ADDENDUM NUMBER THREE

DARLA MOORE SCHOOL OF BUSINESS CONSTRUCTION – BP-3
ENCLOSURE/SITE/MEFP/INTERIOR
UNIVERSITY OF SOUTH CAROLINA
STATE PROJECT NUMBER H27-6069-AC-3

DATE OF ISSUE: June 22, 2012

FLOOR PLAN - LEVEL 0 - ROOM TAG, DOOR TAG REVISIONS
 REF. DWG #A1100
 SHEET TITLE :

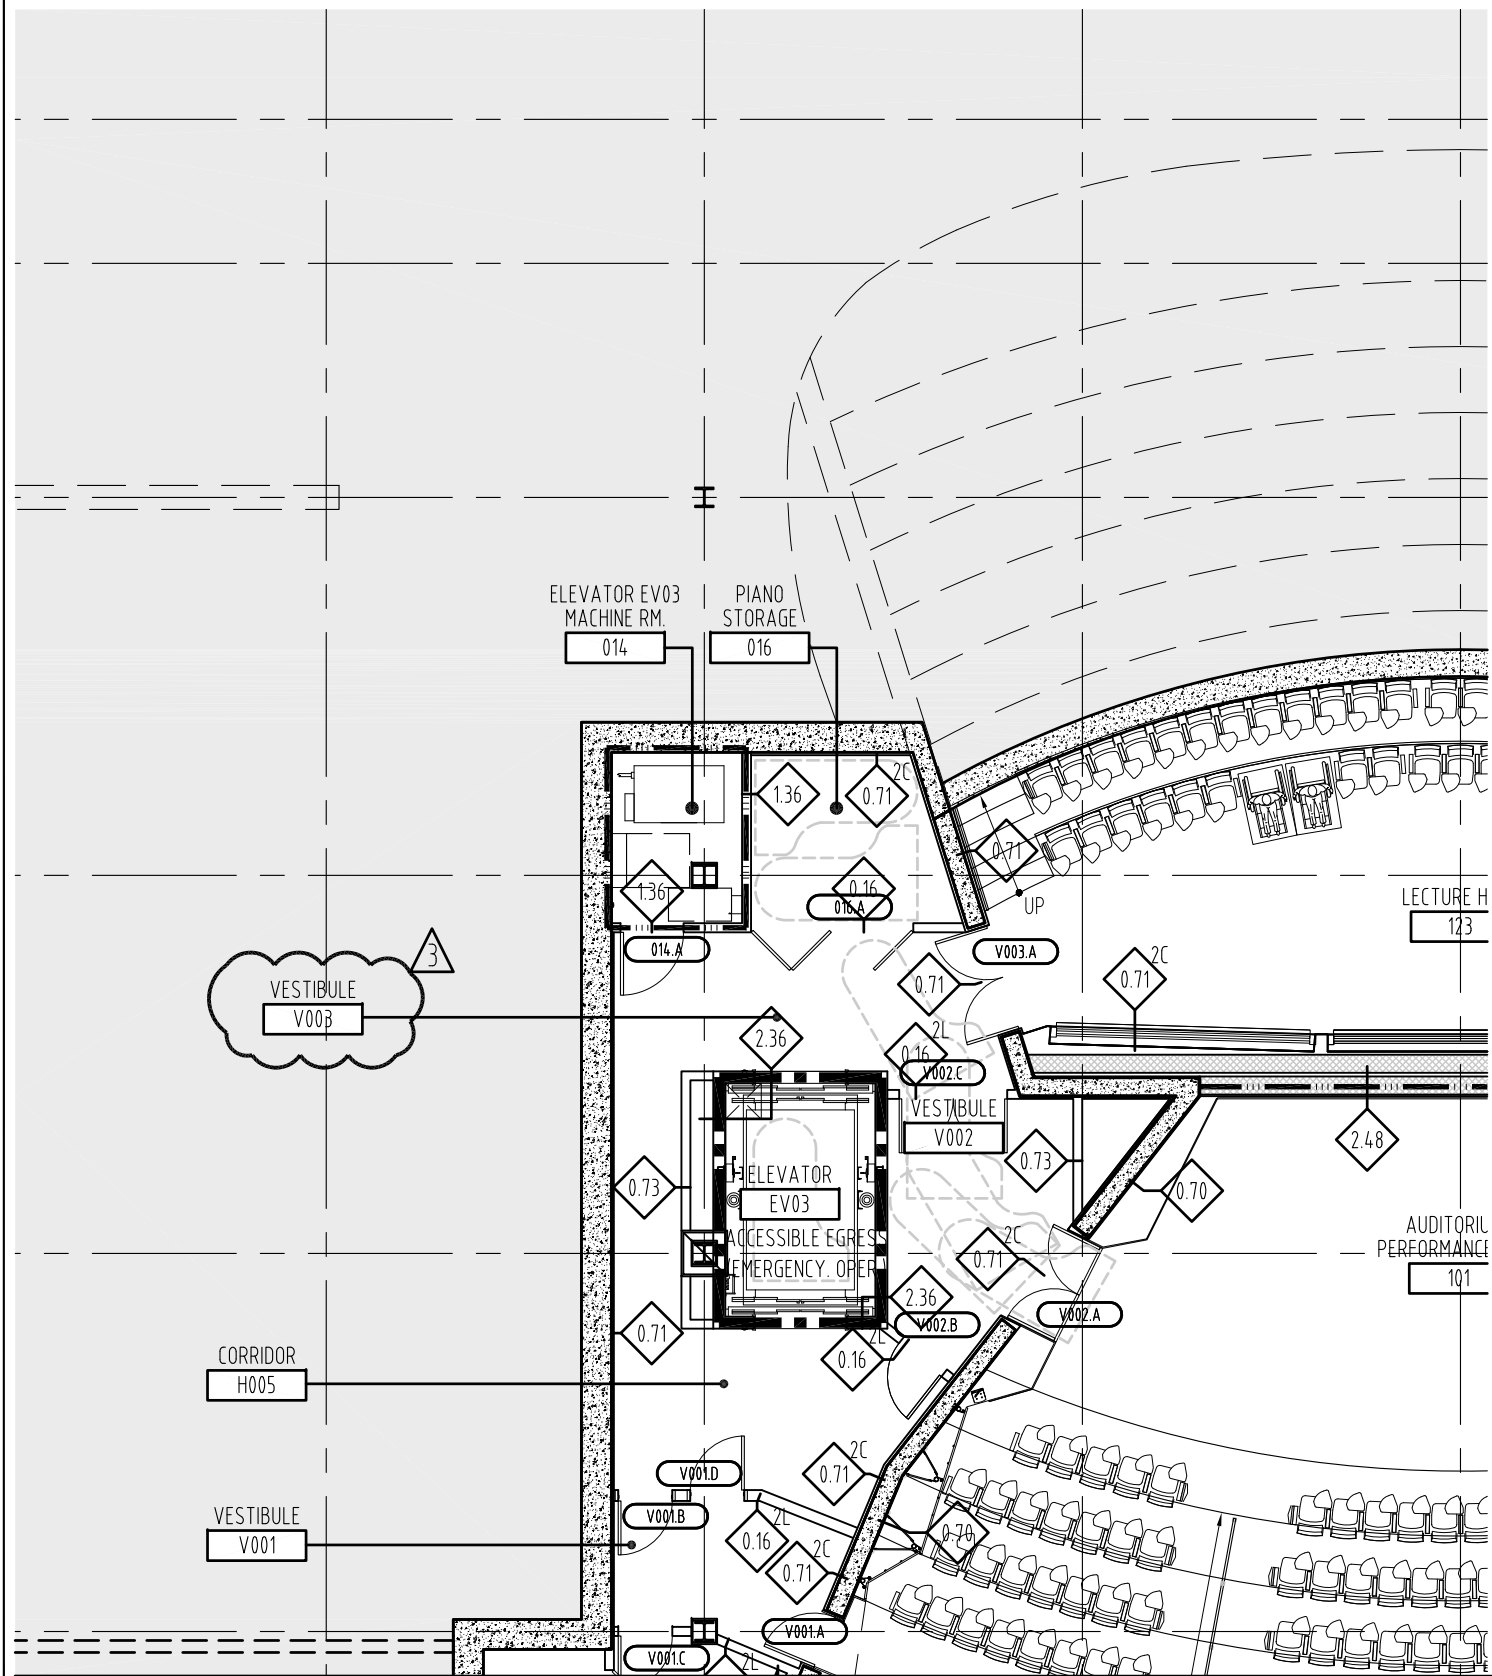
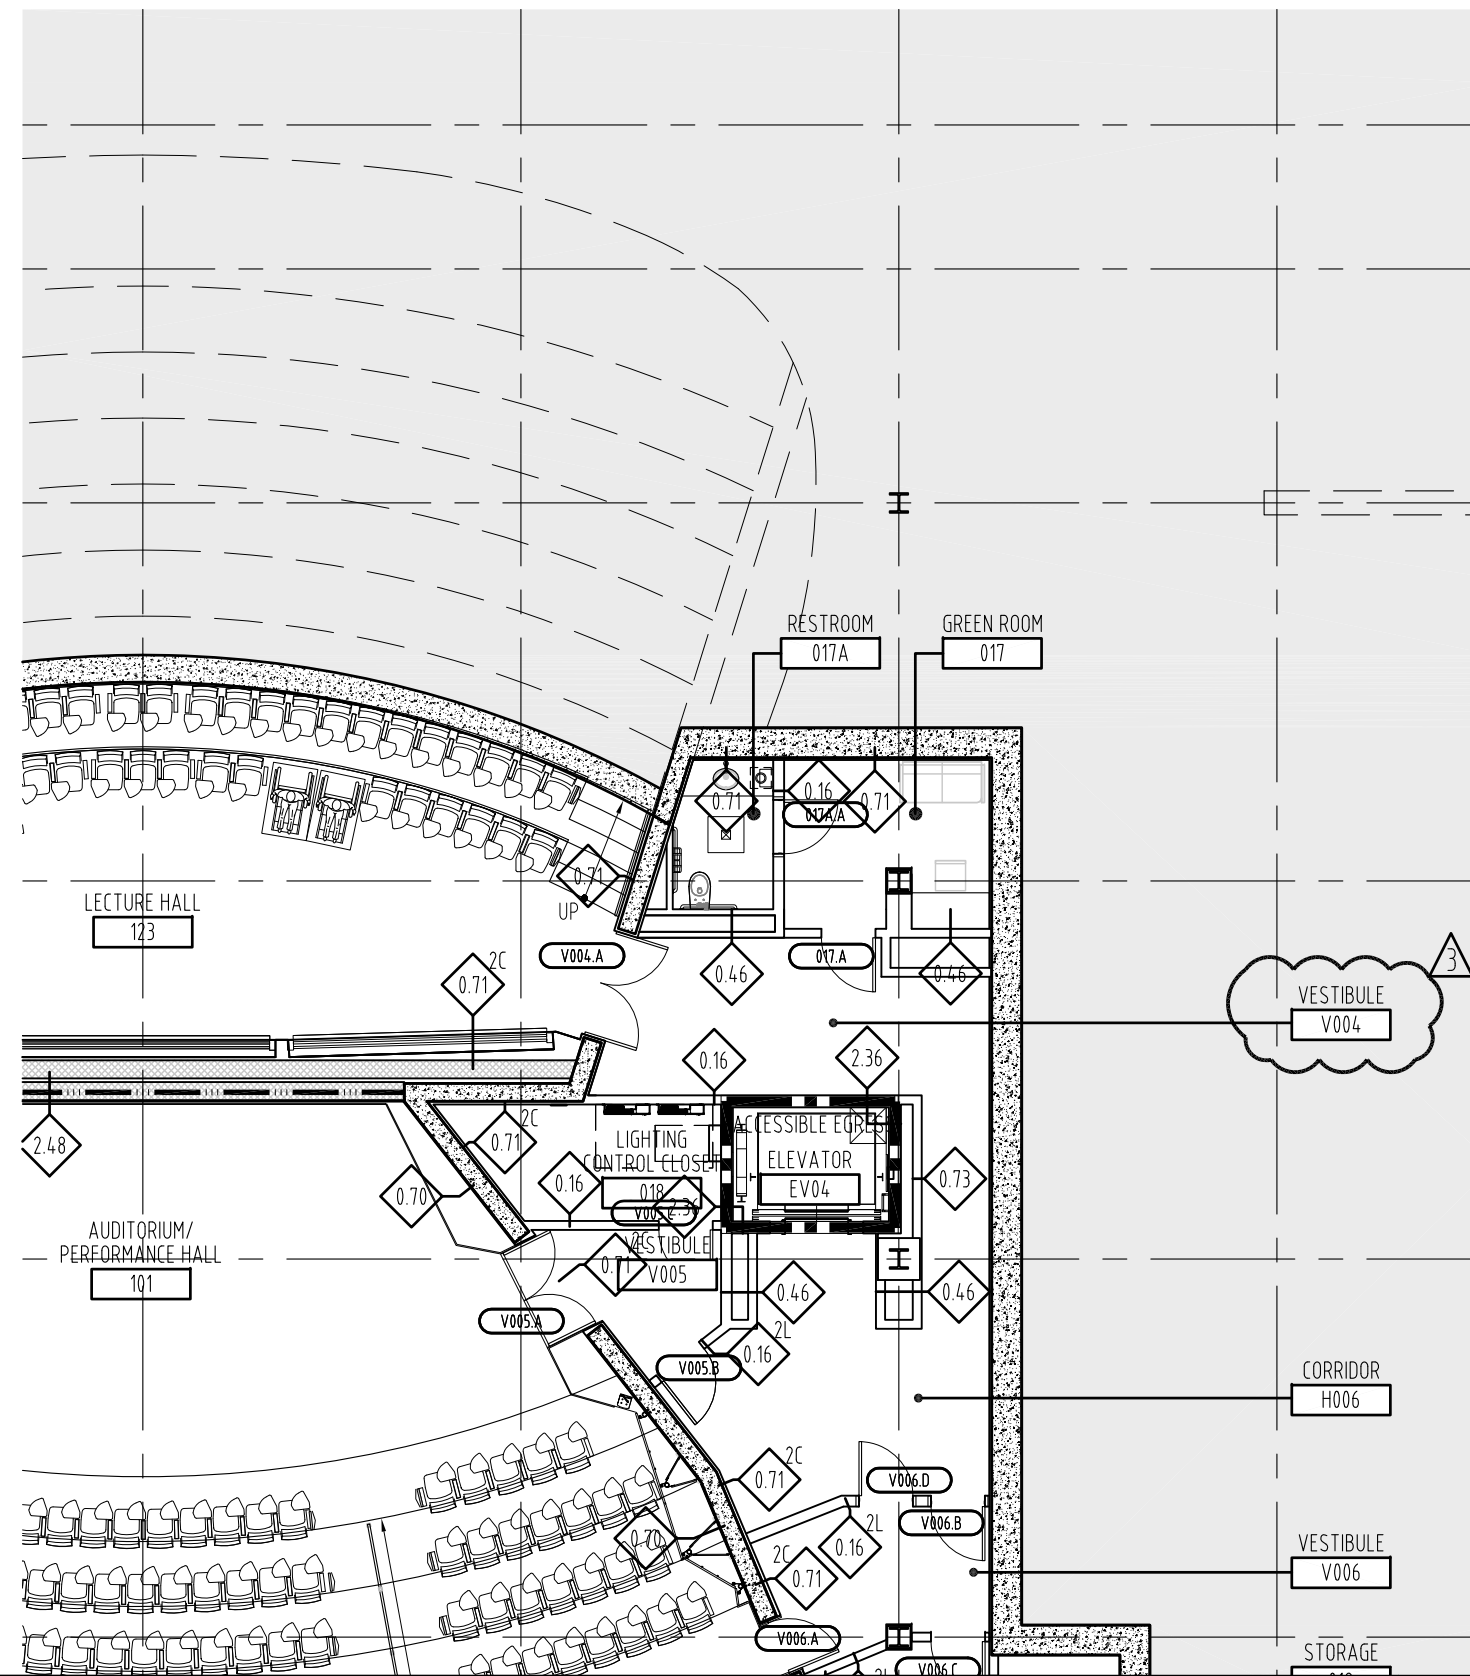
| 1. | Sheet A1100, A1100A, A 1100E: Floor Plan - Level 0. Refer to A-SK-047 & A-SK-048 - Door and room tag revision. |

ENLARGED FLOOR PLAN - LEVEL 1 - ROOM TAG, DOOR TAG REVISIONS
REF. DWG #A1110B, A1110D
SHEET TITLE :

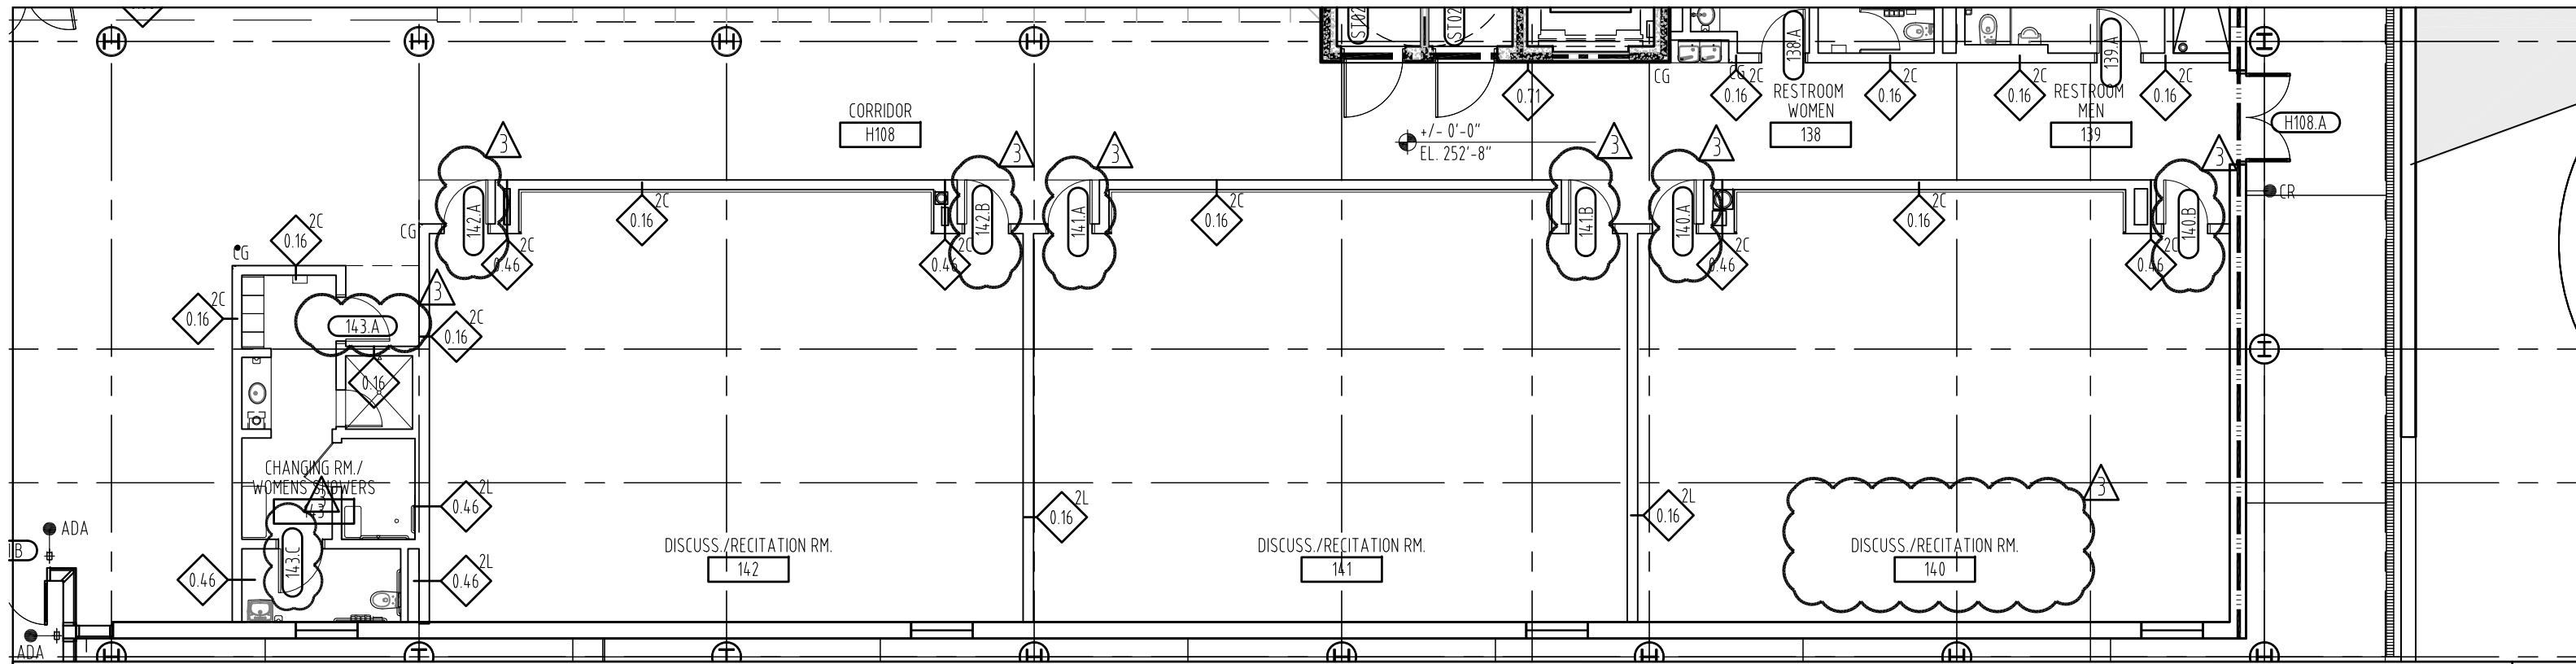
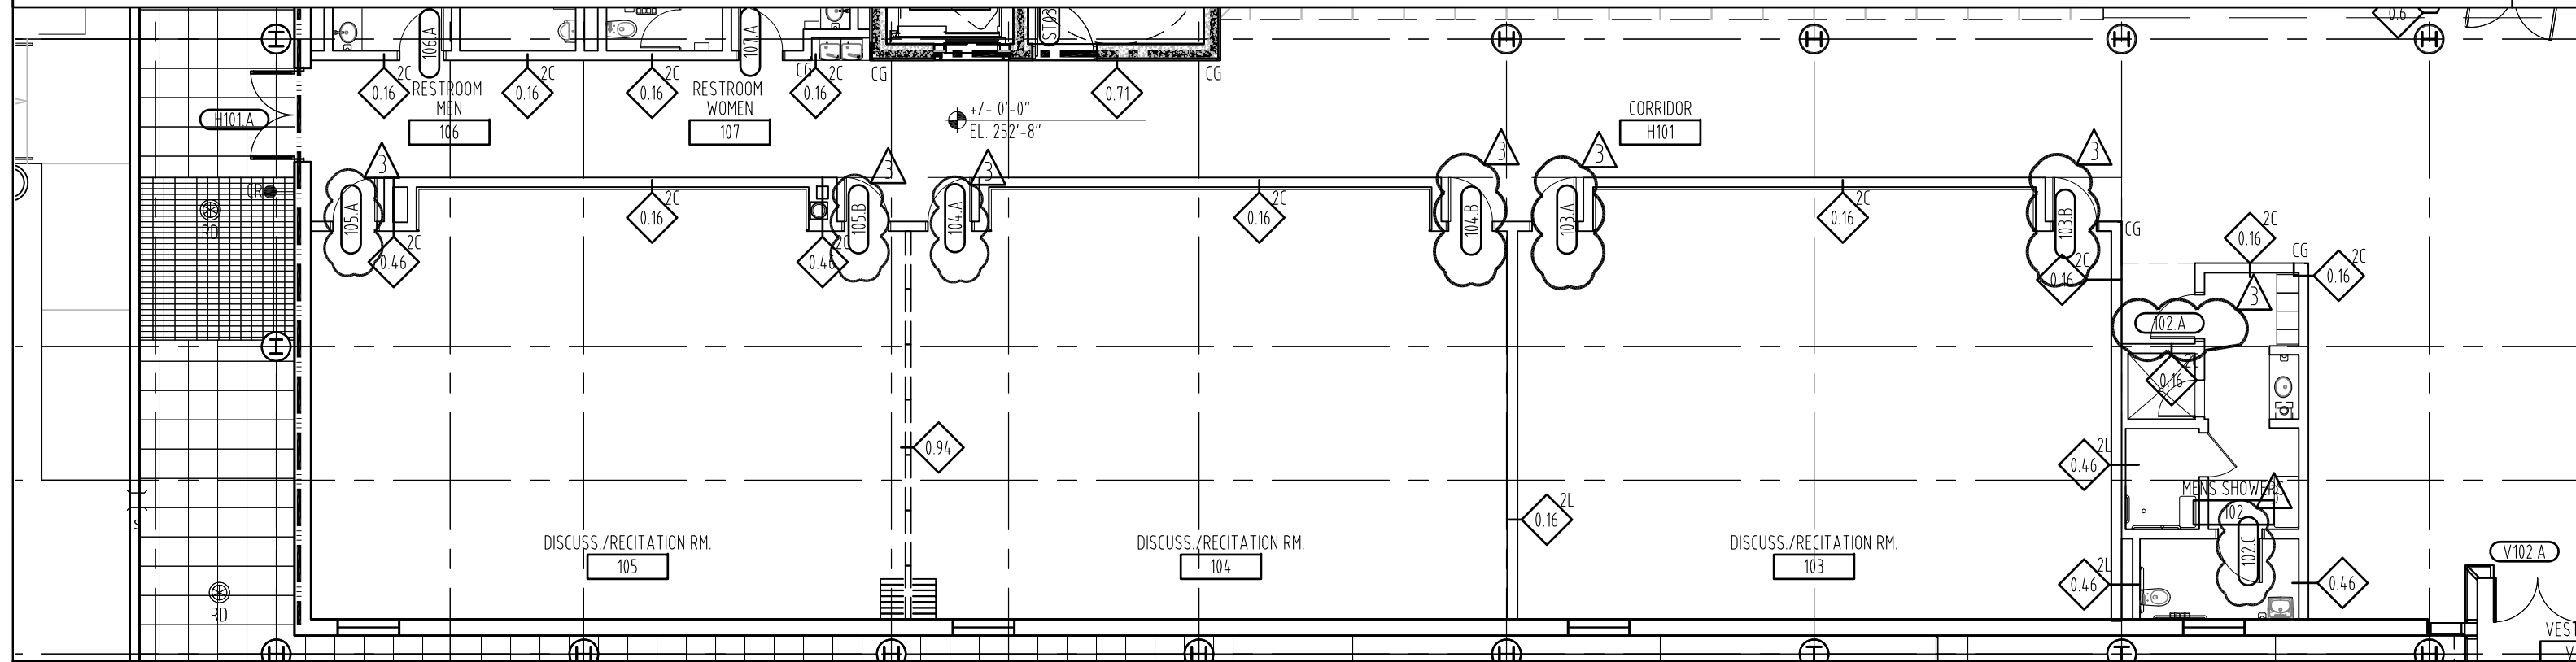
| 2. | Sheet A1110B, A1110D: Enlarged Floor Plan – level 1. Refer to A-SK-049 - Door and room tag revision. |
